**Technical Memorandum**

**From: Tom Myers, Ph.D., Hydrologic Consultant**

**Subject: Review of the SNWA Pipeline Draft Environmental Impact Statement**

Figure 1: Snapshot from Figure 6-9 (SNWA, 2009) showing unweighted residuals.

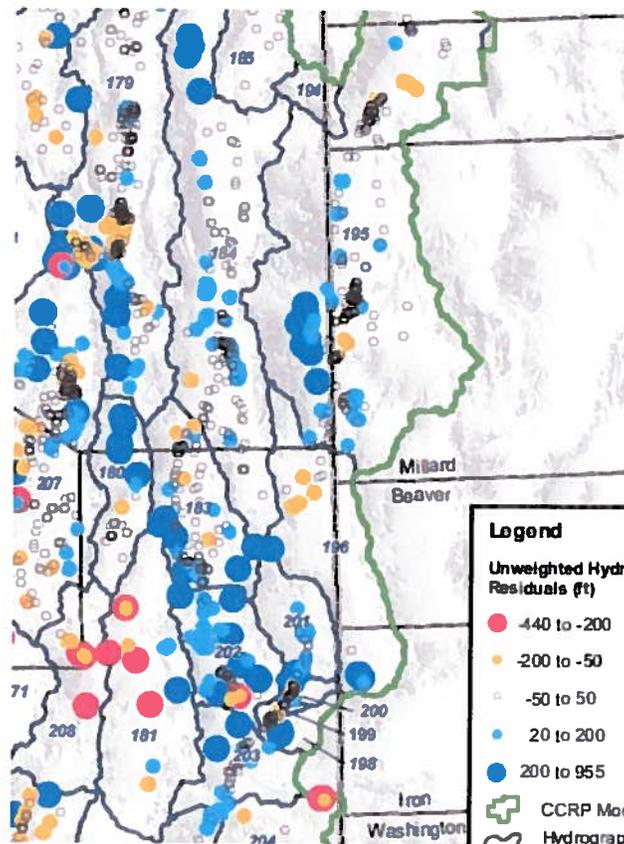
**SNWA's model calibration is biased to look better than it actually is.** SNWA presented unweighted residuals, in Figure 6-9 (SNWA, 2009), which shows extreme bias in the distribution of residuals. In the area of Dry Lake and Pahroc Valleys, six residuals are between -440 and -220; five more are between -200 and -50 (Figure 1). Just east of Dry Lake Valley, in a trend that looks very much like the PRISM precipitation overestimates in Patterson, Lake, and Cave Valleys, are at least ten residuals from 200 to 955 and another ten from 20 to 200 (Figure 1). The CCRP model ranges from gross overestimation of head in Dry Lake/Pahroc Valleys (simulated exceeds observed in a negative residual) to gross underestimation of heads 10 to 20 miles to the east.

Two other obvious problems are the high positive residuals in north Spring Valley and along the mountain front in Snake Valley (Figure 1). The model does not accurately simulate the water table in the higher elevations along the boundary of the valleys. There should be little confidence in the simulated drawdown in these areas, potentially biasing the predicted results.

Figure 2: Snapshot of hydrogeology and calibrated K, model row 359. This section crosses Pahrnagat and Coyote Spring Valley. (file xs\_rum\_rows-rev2-7o-map-hd-kh-s-1lay-ucth814-1-4748.pdf). The blue in the upper figure is a cluster of contours.

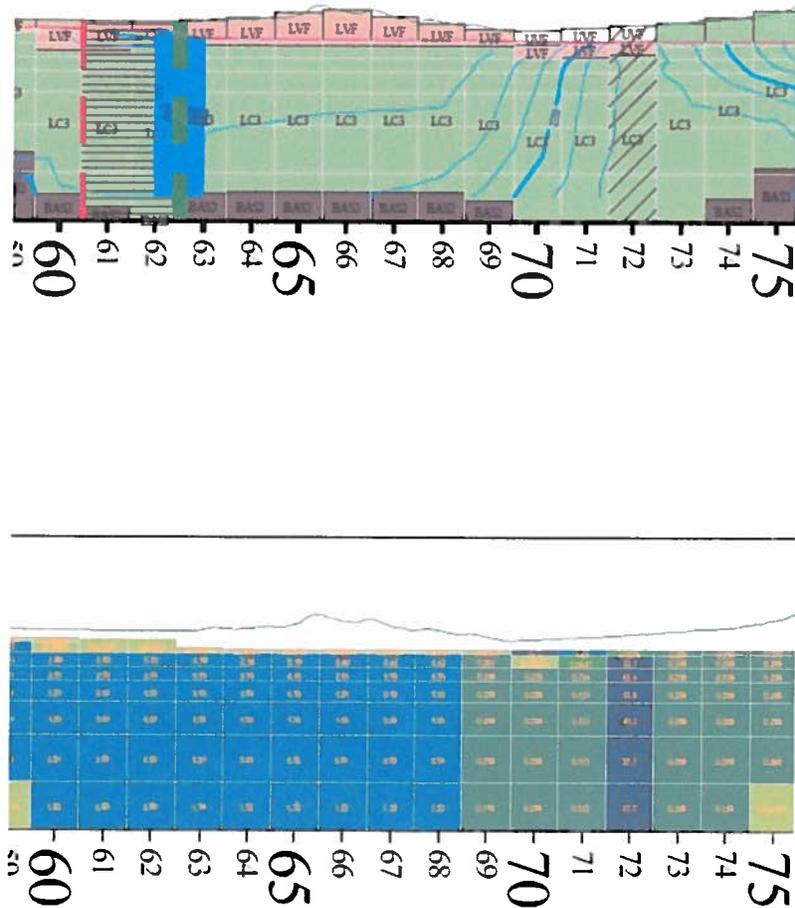
The Pahranagat shear zone causes a head drop of about 700 feet across one model cell, as represented by the blue in the hydrogeology at column 62 (Figure 2); this is modeled with a series of HFBs. Further east (right) in column 72 is a conductive fault in LC3 (lower carbonate rock). The conductivity (K) in the fault ranges from 17 to 62 ft/d, over 3281 feet, while the

surrounding LC3 cells have K about 0.5 ft/d. The high K fault runs north/south through Coyote Spring Valley to just south of the Pahrnagat Shear zone (Figure 3); the fault is shown on Figure 3 just east of the highway; it ends approximately where it intersects the shear zone. Based on K, this fault zone would transport vastly more groundwater than the surrounding rock.

Figure 3: Snapshot from Plate 2, Rowley et al (2011).

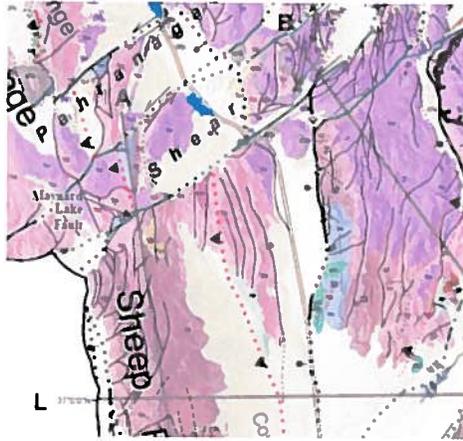
The source of the Pahranaagat springs in SNWA's model is a highly conductive fault running down the middle of Pahranaagat Valley. This fault gathers and transports groundwater from the north and west; K in the carbonate rock ranges to 30 ft/d for one or two column widths. The Pahranaagat shear zone is simulated with a series of HFBs which prevent much of the flow from passing and also force groundwater to the surface to form the springs. Flow from the east to the central part of Pahranaagat Valley is blocked by a normal fault that bounds the east side of the valley. The head drop across the HFB is about 300 feet (row 336); some flow occurs during steady state conditions but the HFB would be slow to respond to upgradient pumping. SNWA protects the Pahranaagat Springs with an HFB that has not been proven on the ground.

Figure 4: Hydrogeology and K values for row 407. (file xs\_rum\_rows-rev2-7o-map-hd-kh-s-1lay-ucth814-1-4748.pdf)

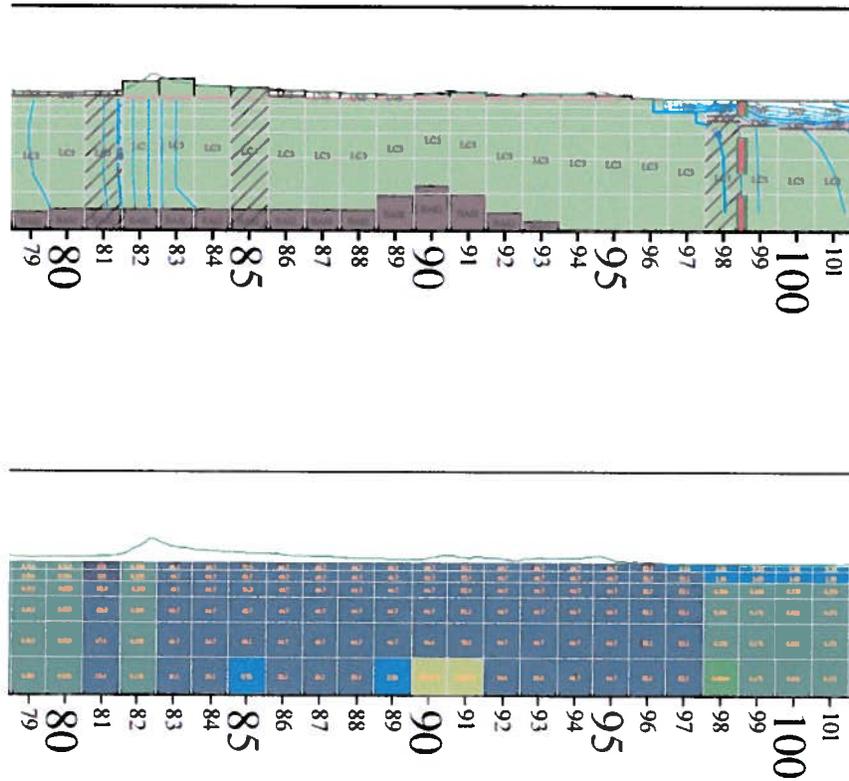
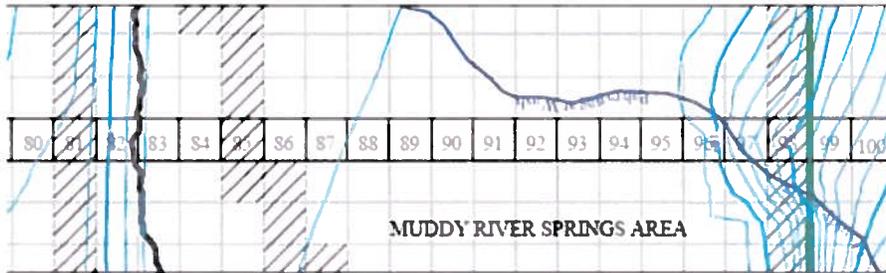
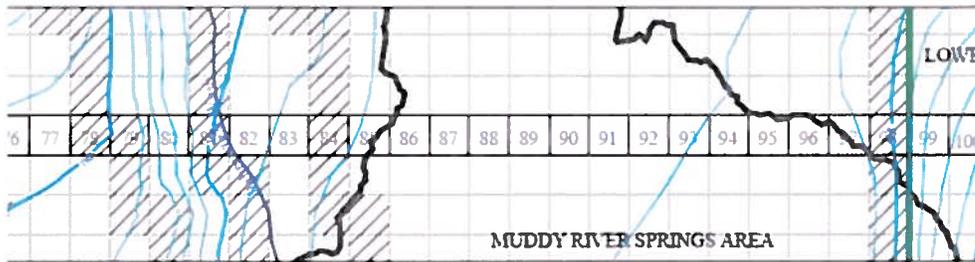
Further south, three faults converge in Coyote Spring Valley which allows groundwater to move to the Muddy River Springs area through a zone of very high K LC3 rock. Figure 4 shows two of the faults and high K zones right of the faults; Figure 5 shows the convergence of these faults and the fault on the east which impedes the flow causing it to surface at the springs. Figure 6 shows the three faults north of the springs near their convergence into the broad high K LC3 material. These figures demonstrate how a model simplifies complex geology but the problem with this is the broad zones with very high K cover as much as 20 model rows by 15 columns, or about 300 square kilometers. There is no geologic evidence for such a broad fractured zone in this area. Such a zone may bias the results for this area. The springs probably discharge from a narrow highly conductive fracture zone which could be drained sooner by pumping than would a 300 square km, 10,000 feet thick zone, with high K.

Figure 7: Snapshot of portion of row 128 in center of Spring Valley showing hydrogeology (upper) and K (lower). (file xs\_rum\_rows-rev2-7o-map-hd-kh-s-1lay-ucth814-1-4748.pdf)

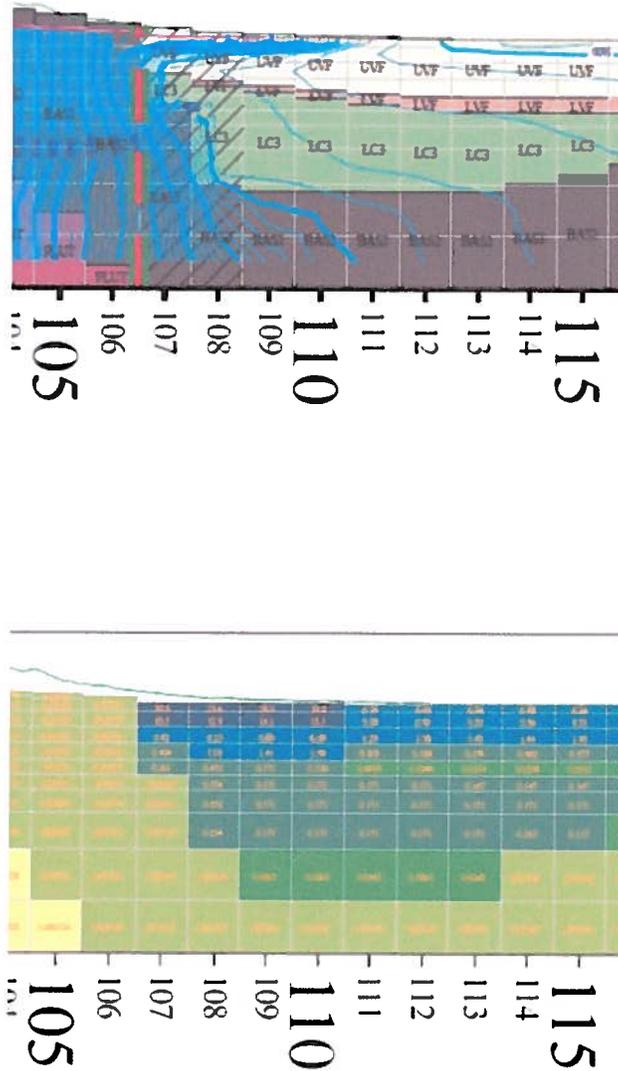
The CCRP model simulates Spring Valley with faults on each side, but only the normal fault on the west side affects the flow (Figure 7). An HFB runs between the bedrock and fill, causing a significant head drop. The bedrock is all low K, therefore the flow into the fill is probably low; the northern portion of Spring Valley has mostly mountainfront recharge. The east side fault shows as large displacement, but the K is not significantly different from the surrounding rock.

SNWA simulates the fill in Spring Valley as high to very high K. The primary feature is that the fill is modeled as a bowl, with high K fill surrounded by bedrock. SNWA models specific storage in lower layers of the fill, 5000 ft bgs, as 0.015. This imparts a huge bias on the predicted results because much more water is released for a unit drop in head than is realistic. Anderson and Woessner (1992, Table 3.4) specified a range of specific storage values ranging from 0.02 to 0.000049  $m^{-1}$  for material ranging from clay through dense sandy gravel; the high range is for plastic clay, not the type of material found in Spring Valley. Halford and Plume (2011) used a specific storage of  $2 \times 10^{-6} ft^{-1}$  for their layers 2 through 4. These references support the use of a lower specific storage than was used by SNWA (2009). **SNWA's choice would improperly minimize the predicted drawdown by causing the model to release more water to pumping for a given drawdown than is realistic.** It biases the drawdown prediction to be much lower than would occur in reality.

Figure 8: Snapshot of row 160 showing hydrogeology from Steptoe Valley (left) to Spring Valley. (file xs\_rum\_rows-rev2-7o-map-hd-kh-s-1lay-ucth814-1-4748.pdf)

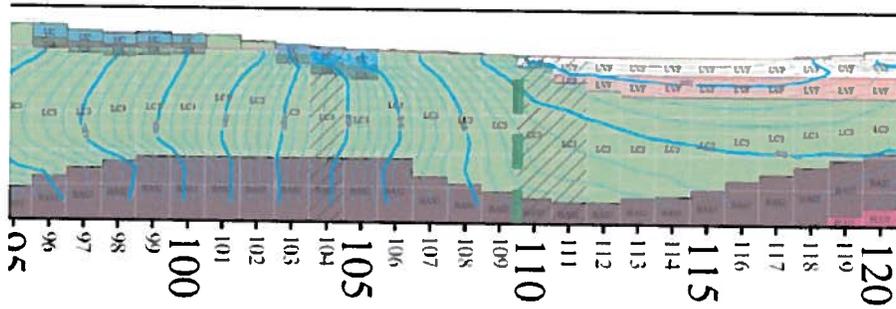
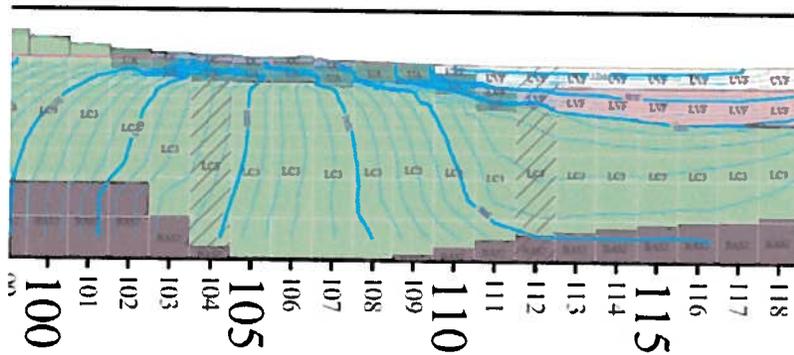
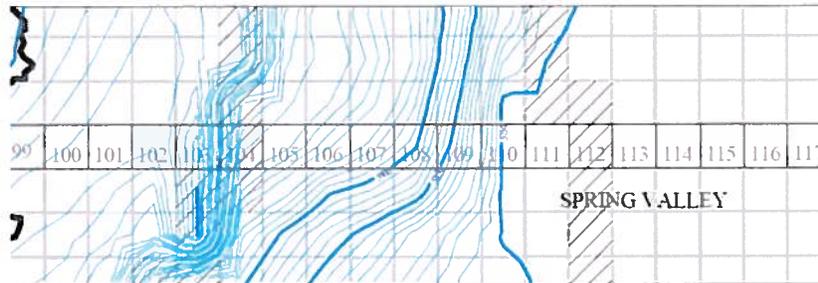
Groundwater contours along row 160 show a gradient through carbonate rock from Steptoe to Spring Valley (Figure 8). The model includes an HFB, but no mounding of contours. This is an example of how the CCRP model allows flow from Steptoe to Spring Valley, in contradiction to their geology models. Figure 9 and 10 demonstrate how a groundwater level contour map can show a divide while there is clearly flow at depth.

Figure 11: Snapshot for Row 100 showing groundwater contours and hydrogeologic formations near Gandy Warm Springs, near column 148.

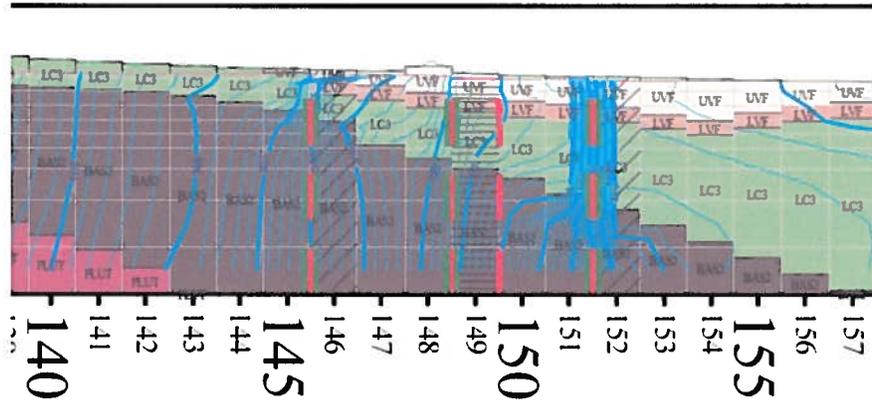
SNWA misses the two most likely sources of water to the spring: the substantial carbonate rock on the northeast side of the Snake Range southwest of the spring and interbasin flow from Spring Valley. A fault diverts flow from the Snake range. SNWA discounts the idea that interbasin flow from Spring Valley could support the spring (NMR, page 5-6). This is curious because the model simulates 11,800 af/y of interbasin flow to just north of Snake Valley which is of the same order of magnitude as the approximately 16,000 af/y estimated for this region in BARCASS (Welch et al, 2008, Figure 41). If even a third of that amount combined with carbonate

recharge in the northeast portion of the Snake Range, the Gandy Warm Springs flow could be accurately reproduced.

Figure 12: Snapshot of row 202 showing hydrogeology (top) and K values near Shingle Pass. (file xs\_rum\_rows-rev2-7o-map-hd-kh-s-1lay-ucth814-1-4748.pdf)

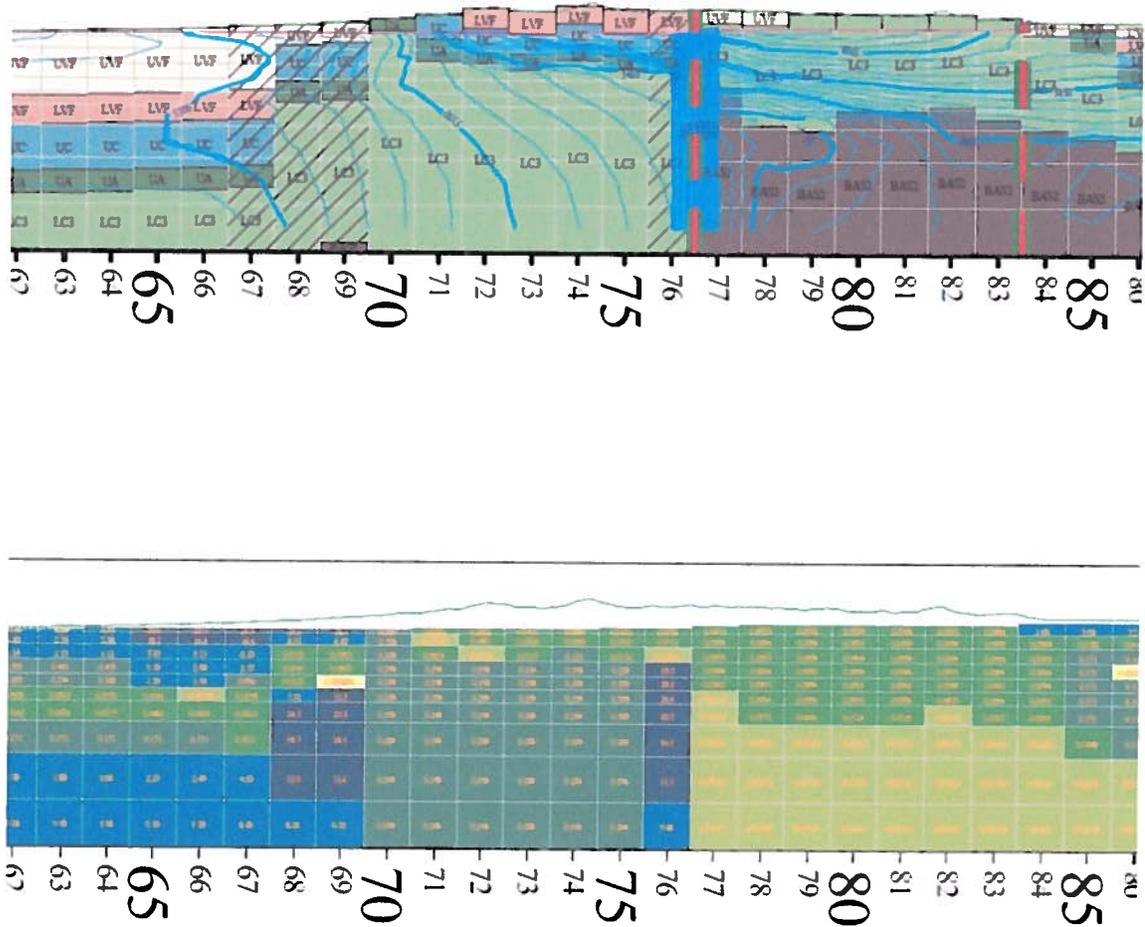
The model conceptualization of Shingle Pass is as complicated as any in the model, with several formations including carbonate rock and several faults (Figure 12). The faults within Cave Valley are simulated with HFBs which prevent flow from leaving Cave Valley. The mountain front faults on the east side of White River Valley have very high K, being high displacement faults. The high K zones extending north and south along the west side of the Egan Range capture and transmit substantial recharge from the mountains to the springs. However, SNWA does not include an HFB on these faults which would force water to surface in

to the springs. Thus, the model is biased so that Cave Valley flow does not support the springs in two ways – HFBs within Cave Valley prevent flow from reaching White River Valley and high K faults along the east side of WRV bring water from the north to the springs rather than from the east.

Figure 13: Portion of model row 126 near the east side of the Snake Range near Baker. White lines are cells, blue lines are groundwater head contours. Other colors represent hydrogeologic units as labeled.

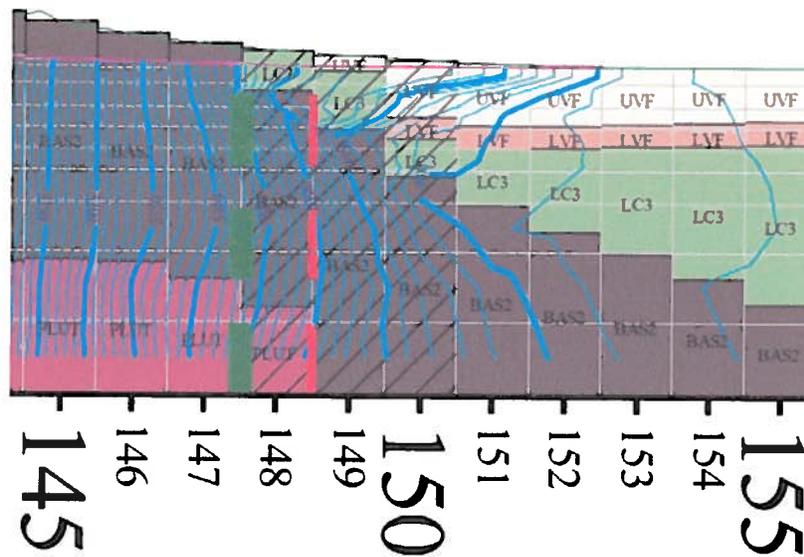
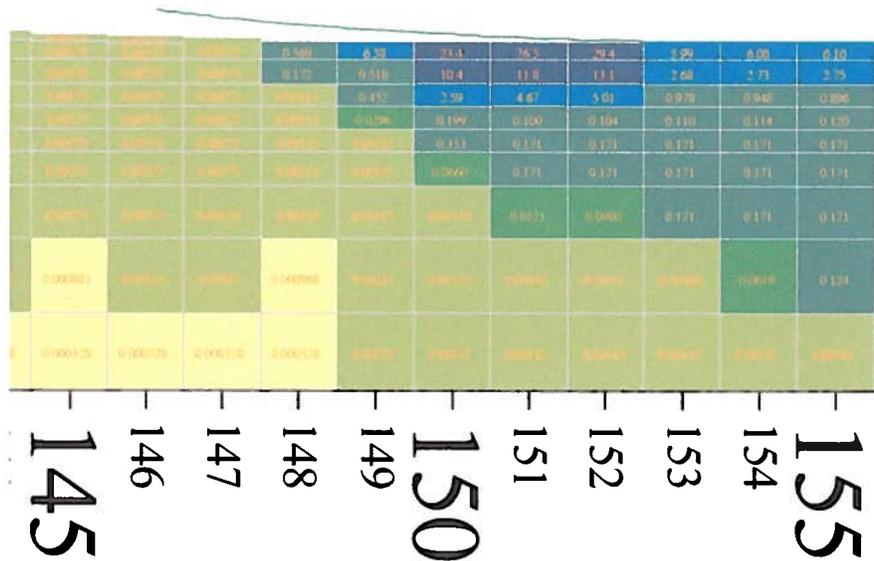
The east front of the Snake Range, near Baker, is a great example of inappropriately averaging formations in one cell. As may be seen (Figure 13), on column 149, the model averages UVF and LC3 properties. In column 150, the model averages LVF and LC3 properties. Considering the conductivity values by cell, the model combined values that differ by more than an order of magnitude (Figure 14). Also, the model would not allow continuous flow among columns within the LC3 unit under Snake Valley because the unit does not match in adjacent cells (Figure 13). This forces the groundwater to follow unrealistic pathways. It would essentially force water in the LC3 unit in column 149 to flow into the LVF unit in column 150.

Forcing the flow into the valley fill, as just described, would **minimize predicted drawdowns from the model**. This is because the model pumps primarily from the valley fill units where the storage coefficient is much higher than in the carbonate units. The HUF2 package, as used by SNWA in this model, forces a connection so that water flow into the LVF where it supplies SNWA's wells, in the model, and may significantly bias the model to underestimate drawdown in these locations.
